UNITED STATES
NUCLEAR REGULATORY COMMISSION
WASHINGTON, D.C. 20555-0001

SUBJECT: BRUNSWICK STEAM ELECTRIC PLANT, UNITS 1 AND 2 – ISSUANCE
OF AMENDMENT NOS. 299 AND 327 TO REVISE TECHNICAL
SPECIFICATION 5.6.5b TO ALLOW APPLICATION OF ADVANCED
FRAMATOME ATRIUM 11 FUEL METHODOLOGIES (EPID L-2018-LLA-0273)

BRUNSWICK STEAM ELECTRIC PLANT, UNITS 1 AND 2

Figure 2: Loop Parts in the Vessel Hydraulics Model (Figure 5-3 (Reference 50))

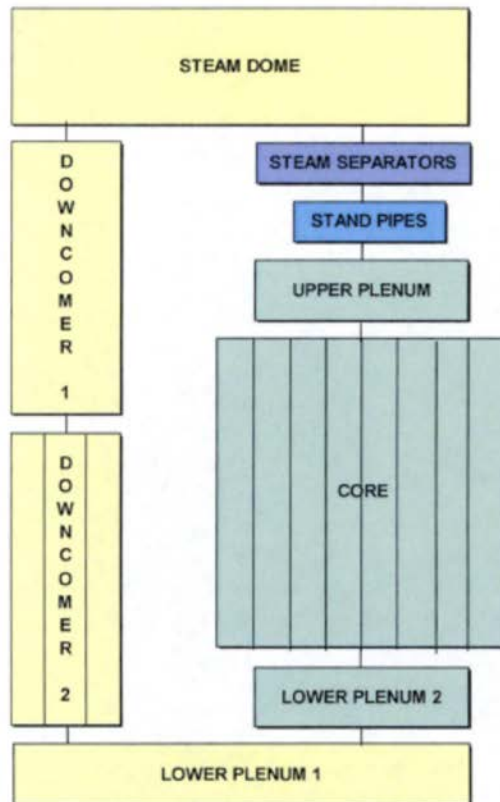
The general system modeling in the submittal consists of nine main components as shown in Figure 2 and is identical to the vessel methodology in the RAMONA5-FA LTSS methodology. [[]]

Accurate modeling of the pressure losses and flow inertia in the vessel flow path is important for correctly determining flow rates and other core parameters during ATWS-I events; this is especially true for in-phase (corewide) oscillations in which the total core flow rate experiences large time-dependent changes that become coupled to time-dependent flow rate changes in the surrounding components. Vessel flow inertia is particularly dependent on the recirculation pump model, which is evaluated in Section 3.5.2.7.1 of this SE; however, the pressure losses and flow inertia in the remaining vessel components are relevant to ATWS-I analyses as well.

Figure 3: Reference Case Dome Pressure During TTWB ATWS-I

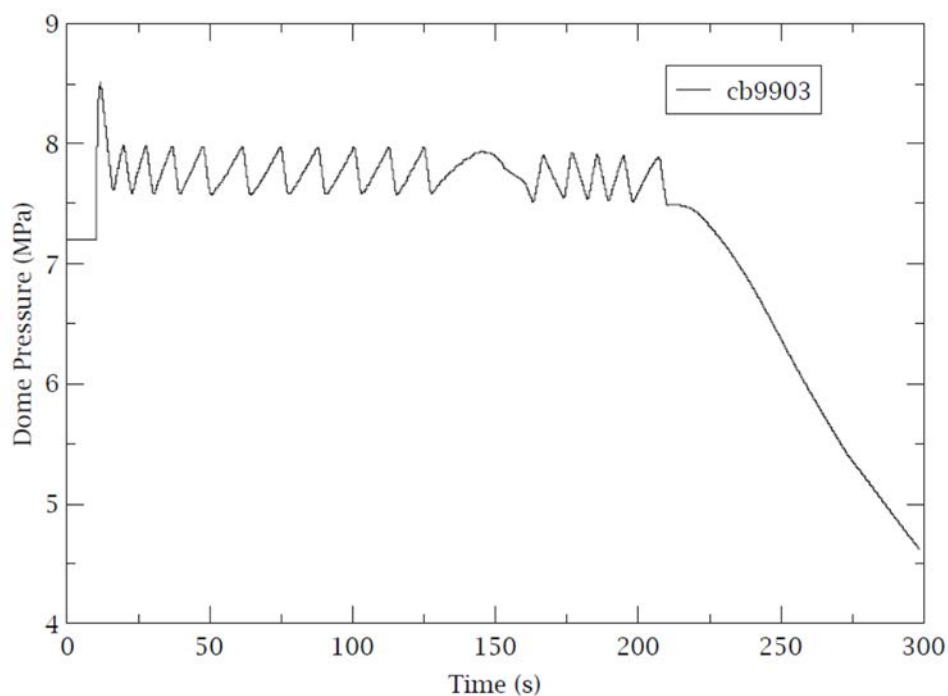
In the TRACE simulation, the turbine trip is initiated after 10 seconds of steady state simulation. The closure of the turbine stop valve causes a sudden increase in the RPV dome pressure, as shown in Figure 3. After reaching a peak, the RPV pressure oscillates according to the SRV lift and seat pressures and remains between ~7.5 MPa and 8 MPa until 200 seconds. The TRACE model of the turbine bypass is relatively simple in that it does not include an electro-hydraulic controller to maintain pressure at a desired setpoint. Therefore, late in the transient, when the reactor power is decreased below the turbine bypass capacity, the RPV pressure begins to decrease in the TRACE calculation. In the TRACE model, the bypass is simulated as a valve that opens and no active control is simulated. However, in the actual plant, the turbine bypass system includes a pressure regulation controller to maintain a desired steam line pressure. This simplifying assumption only produces an error when the reactor power falls below the turbine bypass capacity; this occurs late in the transient, well after mitigating operator actions have shown an effect in decreasing reactor power and fuel temperature.

Figure 4: Reference Case Core Flow During TTWB ATWS-I

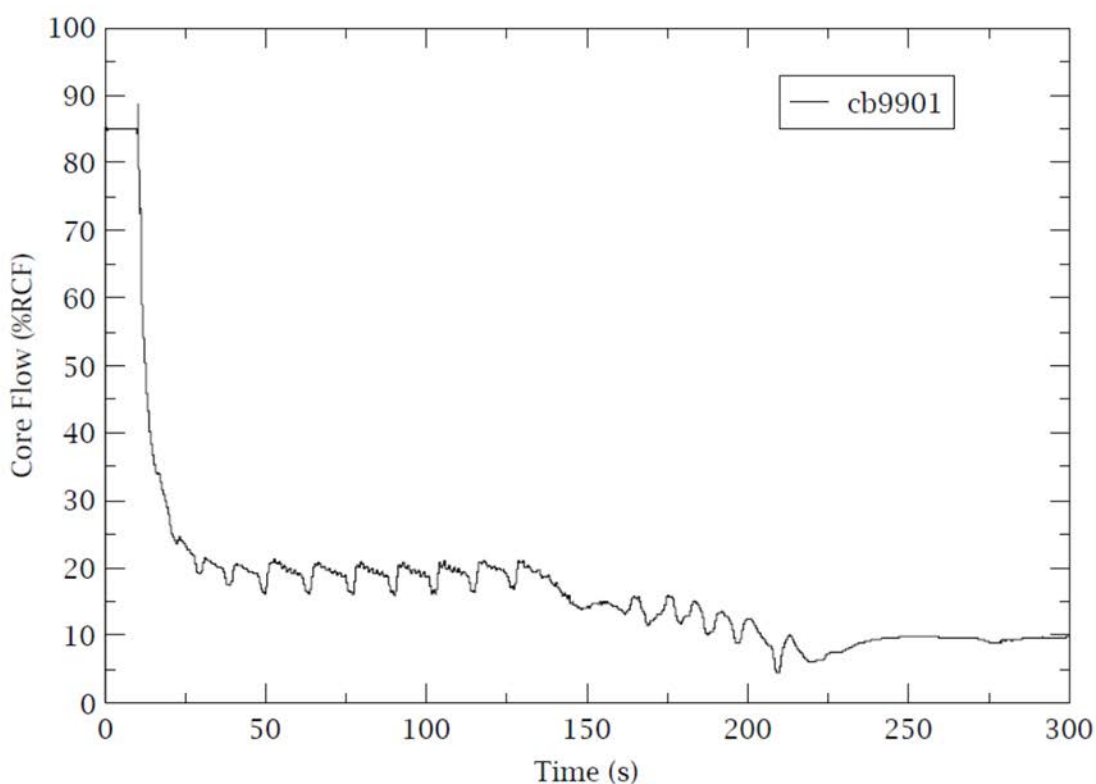
In response to the turbine trip, both recirculation pumps automatically trip. The pumps coast down and the reactor approaches a natural circulation condition. Figure 4 shows the core flow response. During the natural circulation phase, the reactor core flow drops to approximately 20 percent of rated core flow (%RCF). This flow rate appears to be underpredicted because TRACE overpredicts the pressure loss in the separators. Reference 7 provides a description of the TRACE separator models, in particular, how the losses in the separators are higher than the plant design values. A higher separator loss results in larger pressure losses around the loop between the core, separators, and downcomer. This higher loss results in a bias in the TRACE calculation where TRACE underpredicts the natural circulation flow rate. A flow rate between 25 and 30 %RCF is expected, but the current analysis results are conservative because the core flow rate is slightly underpredicted. The core flow is further reduced later in the transient in response to existing mitigating manual operator actions.

Figure 5: Reference Case Reactor Water Level During TTWB ATWS-I

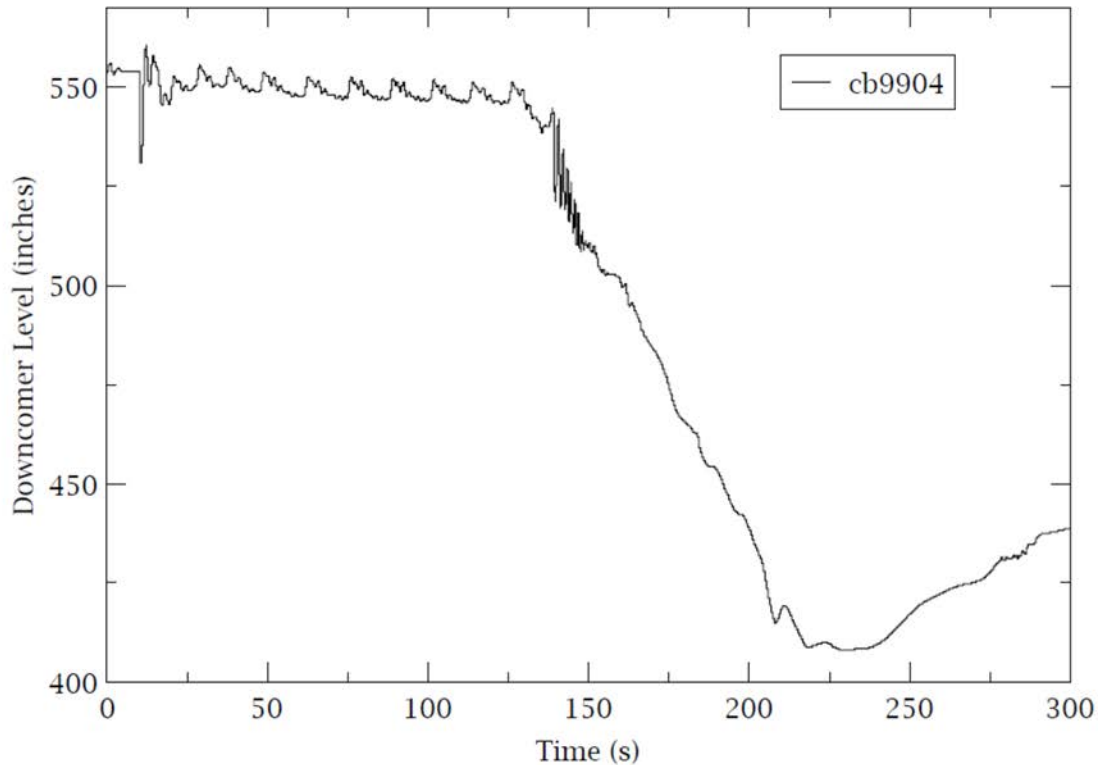
Figure 5 shows that after 130 seconds, the core flow rate decreases in response to a reduction in the reactor water level (see Figure 5). However, in the natural circulation phase, prior to the operator intervention to lower level, the FW temperature is decreasing. The decrease in FW temperature occurs because the turbine trip isolates the flow of extraction steam to the FW heater cascades. This reduction in feed temperature increases core inlet subcooling and power.

Figure 6: Reference Case Core Inlet Subcooling During TTWB ATWS-I

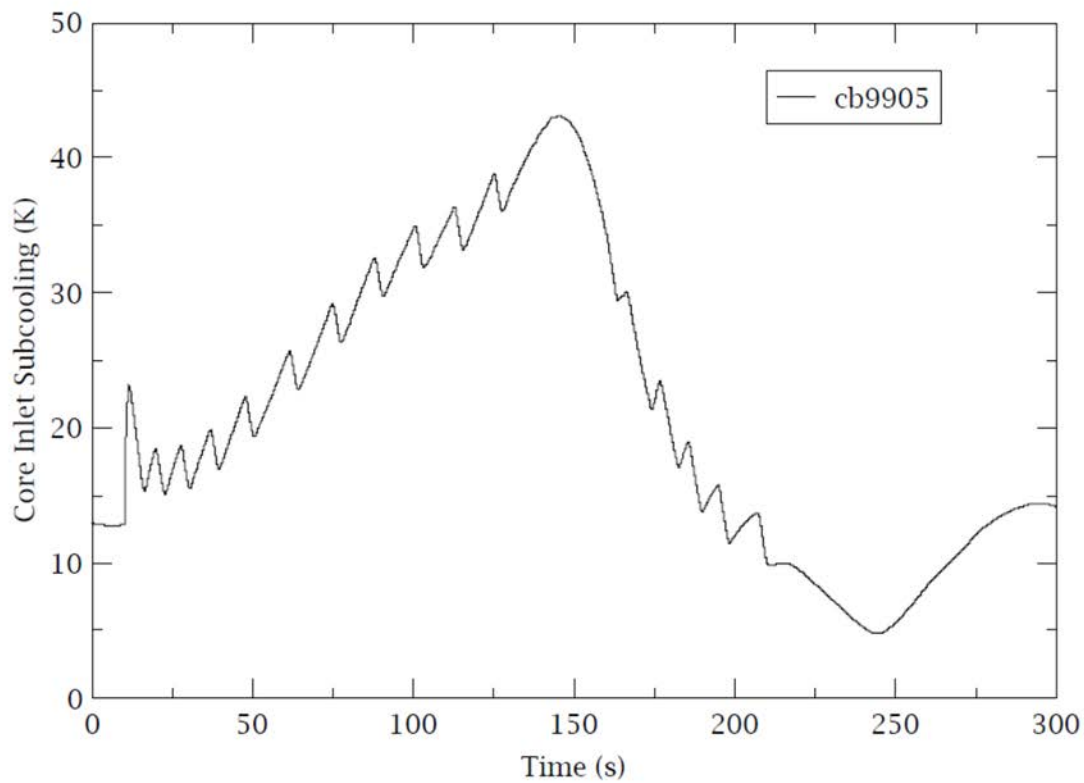
Figure 6 shows the core inlet subcooling. Following the turbine trip, the subcooling steadily increases. There are some oscillations in the subcooling that occur because of variations in the RPV pressure during SRV cycling. The effect of the manual action to lower level is apparent in the late term response of the inlet subcooling (i.e., after 130 seconds), which shows a reversal in the subcooling trend and a significant reduction in the subcooling by 200 seconds.

Figure 7: Reference Case Reactor Power During TTWB ATWS-I

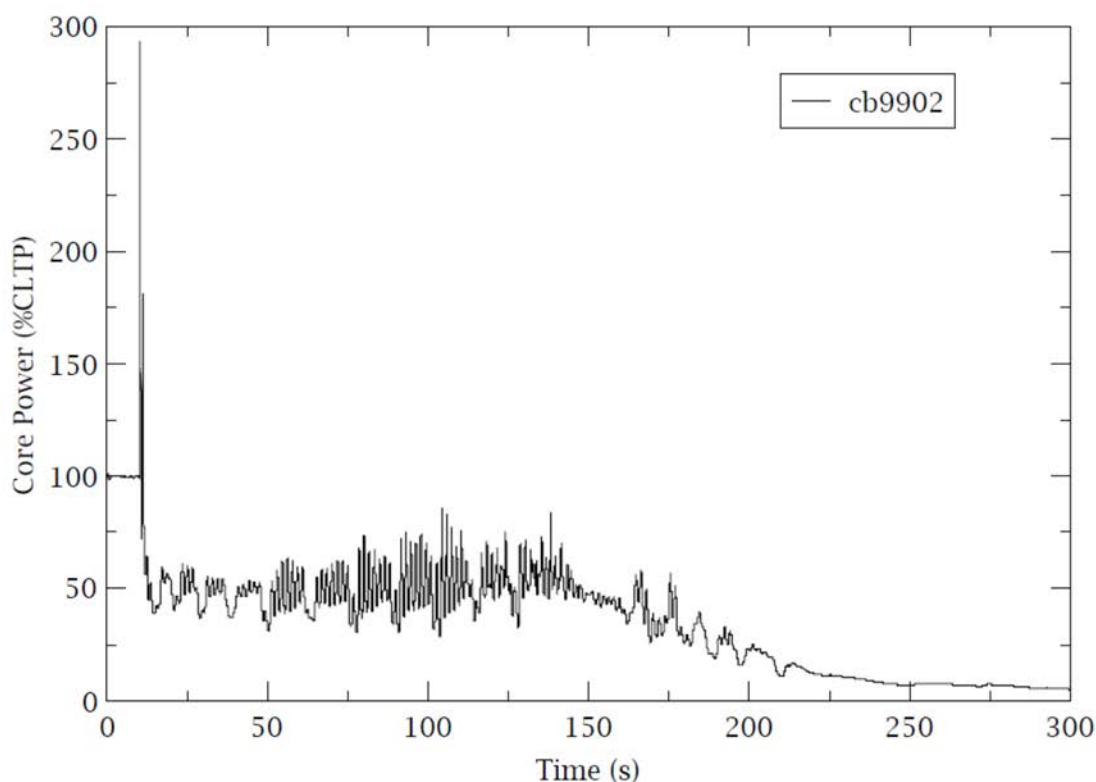
The increased subcooling causes the reactor power to increase prior to operator intervention. Figure 7 shows the transient reactor power response. When the turbine trips, this causes an increase in RPV pressure and void collapse in the core early in the transient, causing the reactor power to spike to nearly 300 percent of the current licensed thermal power (%CLTP). The power increase is arrested by a combination of void formation in the core and Doppler reactivity. The recirculation pump trip causes reactor core flow to decrease, and this causes the reactor power to decrease in kind (due to void reactivity feedback). After this initial phase, the reactor power increases slowly. Some oscillations are apparent in the core power. These oscillations are caused primarily by SRV cycling, but the core appears to be marginally stable in the corewide mode, leading to slowly decaying oscillations following perturbations from the SRVs opening or closing. Gross core power begins to decrease in response to manual operator actions after 2 minutes. While the corewide mode appears marginally stable, the plot of the total core power in Figure 7 does not illustrate how the reactor becomes unstable in the out-of-phase mode.

Figure 8: Reference Case Harmonic Flux Magnitude During TTWB ATWS-I

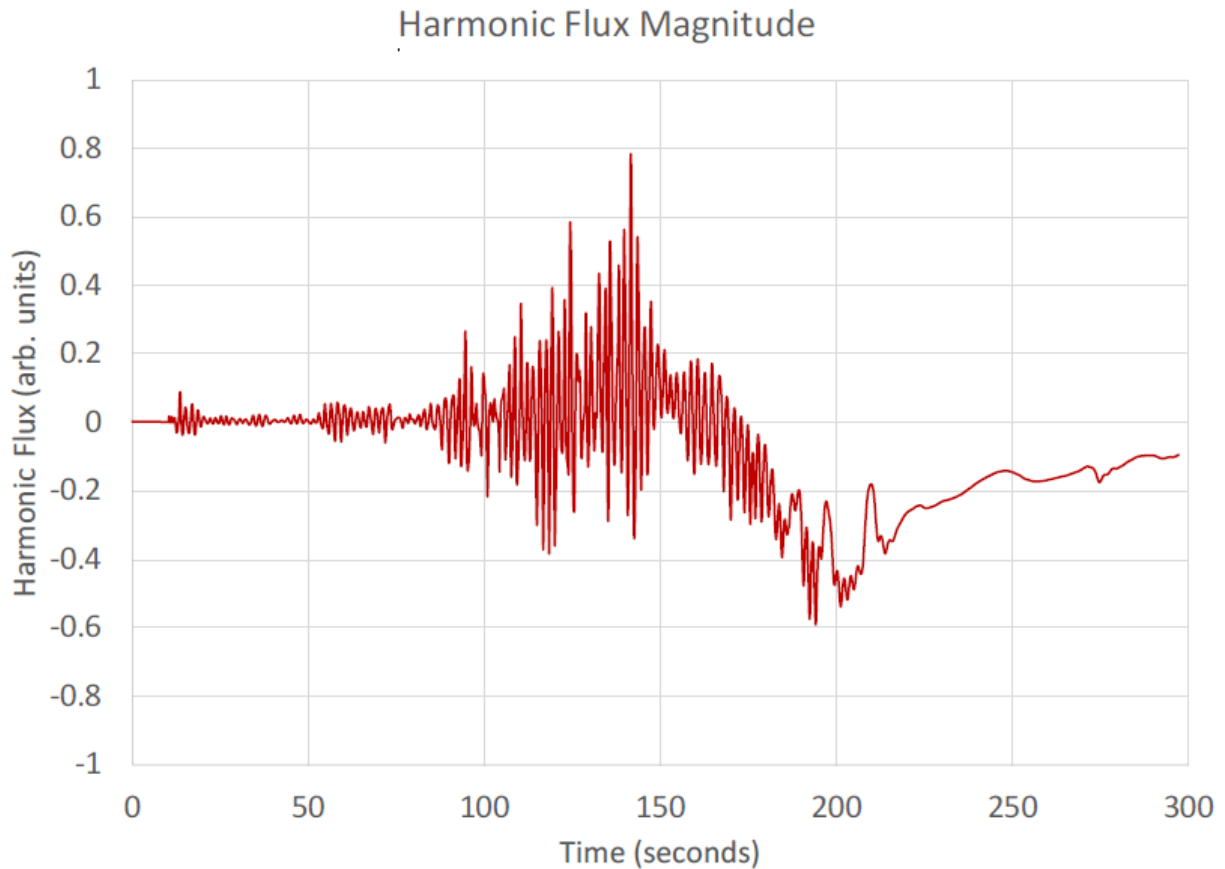
Figure 8 shows the transient response of the first harmonic flux during the event. The result shows that while the corewide mode remains marginally stable, the first harmonic mode becomes unstable and begins to oscillate after approximately 75 seconds.

Figure 10: Reference Case Quadrant 1 and 3 Candidate Hot Channel Flows During TTWB ATWS-I

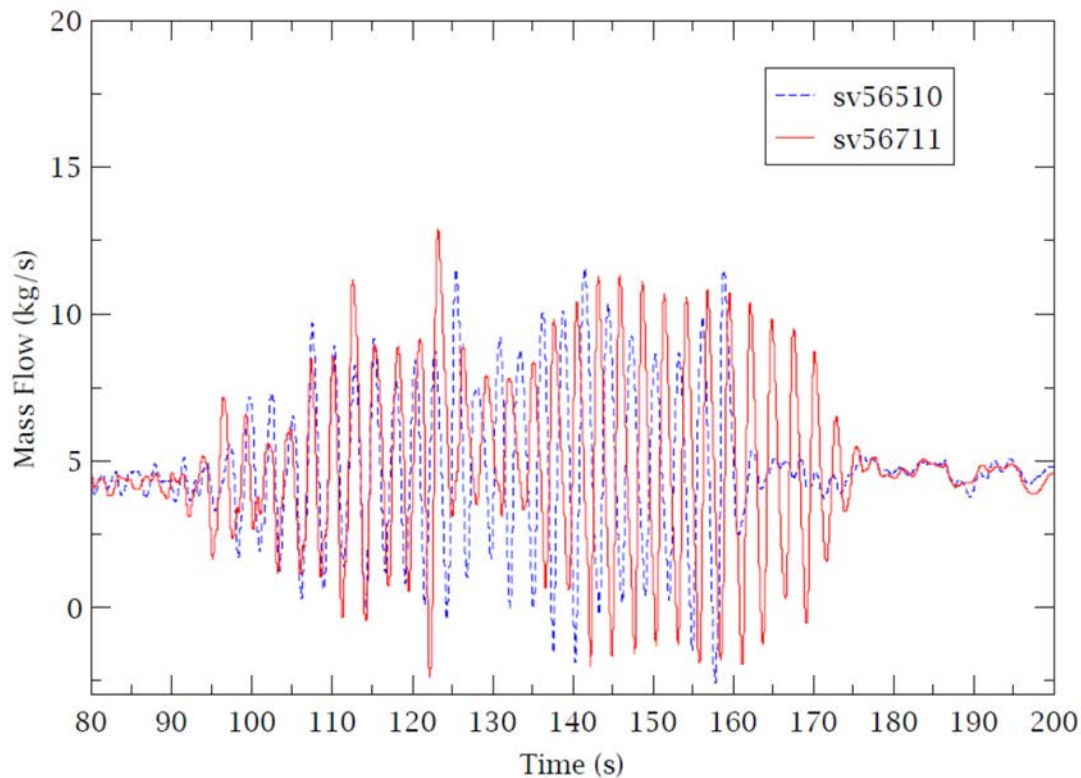
Figure 10 below shows the active channel flows for channel 510 (candidate hot channel in the first, or northeast quadrant, of the core) and the flow for channel 711 (candidate hot channel in the third, or southwest quadrant).

Figure 11: Reference Case Quadrant 2 and 4 Candidate Hot Channel Flows During TTWB ATWS-I

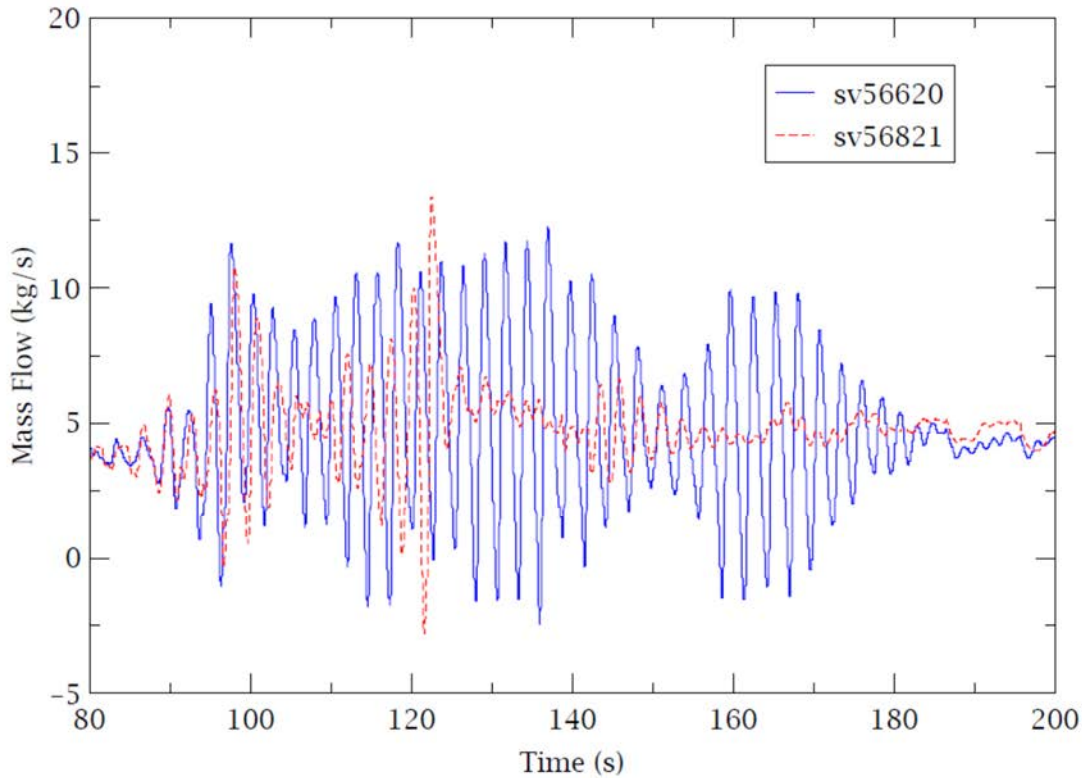
The out-of-phase nature of the oscillation is apparent after 120 seconds because the flow in one channel peaks during the low flow phase for the channel on the other side of the core. Figure 11 shows a similar comparison for channels 620 and 821 (second and fourth quadrants, respectively).

Figure 12: Assembly Power Distribution and Rotation

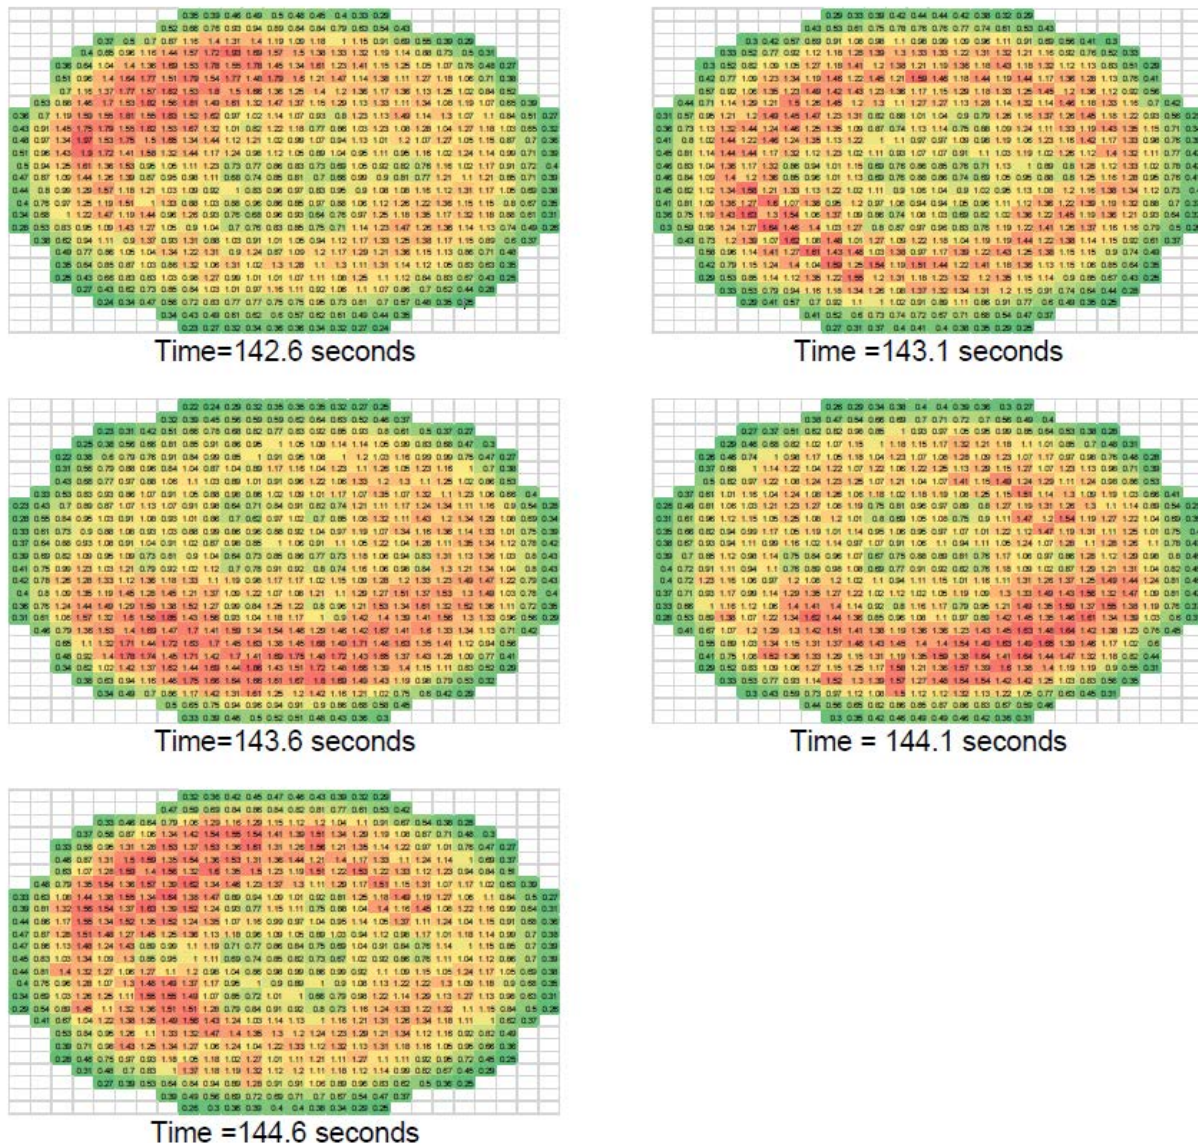
The oscillation is out-of-phase and, in fact, is a rotating mode of oscillation. Figure 12 below depicts the assembly power distribution at various discrete times around 140 seconds. This time range was selected because it is close to the timing of the maximum subcooling and the maximum oscillation magnitude.

Figure 12 below shows how the power peak rotates from the northwest corner, to the southwest, then southeast and so-on. The values provided in the figure indicate the radial power peaking factors for each assembly. The rotating mode was first studied using TRACE/PARCS by Wysocki, et al., and is well understood in terms of modal kinetics (Reference 63).
